# HP LaserJet printer product update

March 2004 • Volume 23

Poor print quality caused by torn fuser film

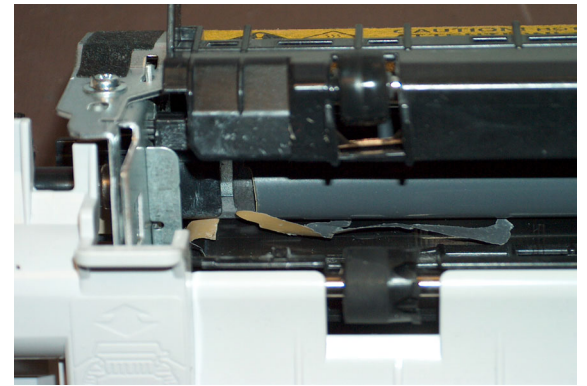
Some users of the HP LaserJet 4200 series printer have experienced printing problems caused by delaminated or torn film on the product's fuser and occurring before the end of the fuser's 200,000-page life. The cause of the tearing film is a flange component set at an excessively angled position on some units. This issue has been corrected, and all fusers produced subsequently will have a proper flange component in place.

Below is an example of print quality problems associated with the torn film. Other indications that the film is torn include pieces of the film coming out with the printed output or the fuser area of the product.

To determine if the fuser film is torn, lift the fuser tray guide and examine the film. Film in good condition appears as a solid gray roller, film in poor condition exhibits the film sleeve shifting to the left and shredded film pieces. If the film is torn, replace the fuser. When this issue occurs before the end of the fuser's 200,000-page life, customers are not charged for the fuser replacement.

Please see service note number Q2425A-03.

Fuser latch countermeasure diagram

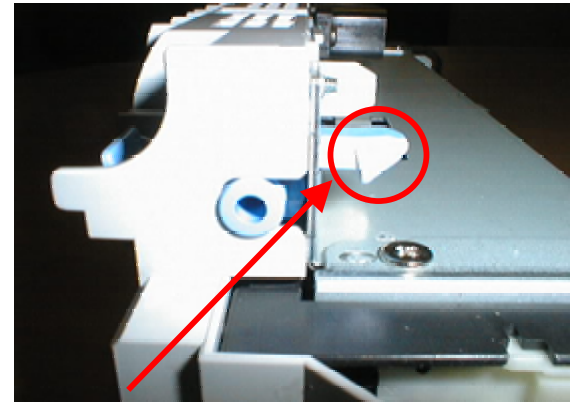
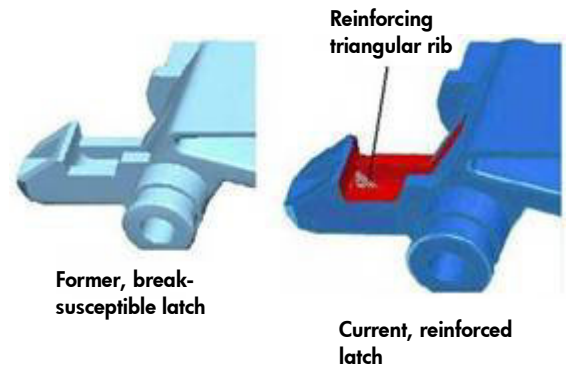
Fuser latches have been breaking before the end of the fuser’s life. The latches in question are the blue grasping latches at the back of the printer used to insert the fuser into position and lock it in place. The latch closest to the gear or drive side of the fuser is most commonly discovered to be broken. Symptoms associated with this issue are a noticeable crack on the latch (see picture, top right) and a resulting break that may cause a grinding noise and paper jams.

A production countermeasure, implemented in October of 2003, consists of a triangular tab in the middle of each latch to help reinforce the plastic in the stress area most susceptible to breaking (see diagram, bottom right). The part numbers have rolled.

Please replace fusers that exhibit cracked or broken latches; part numbers are below:

### Black toner cartridge drive assembly

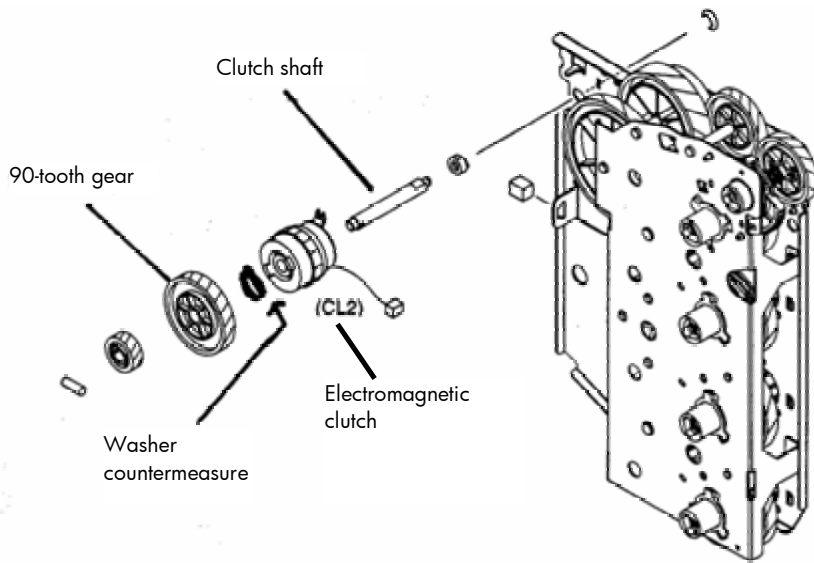
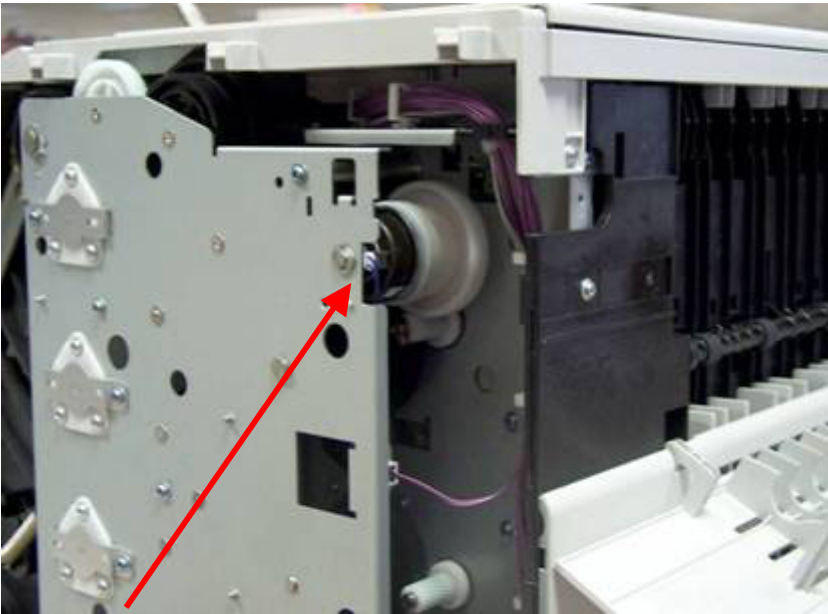
The black toner cartridge drive clutch (CL2) may make a chattering sound that can occur early in a printer's life expectancy. In order to stop the chattering noise, insert the washer countermeasure as depicted below. The washer's part number is XD1-1108-229CN.
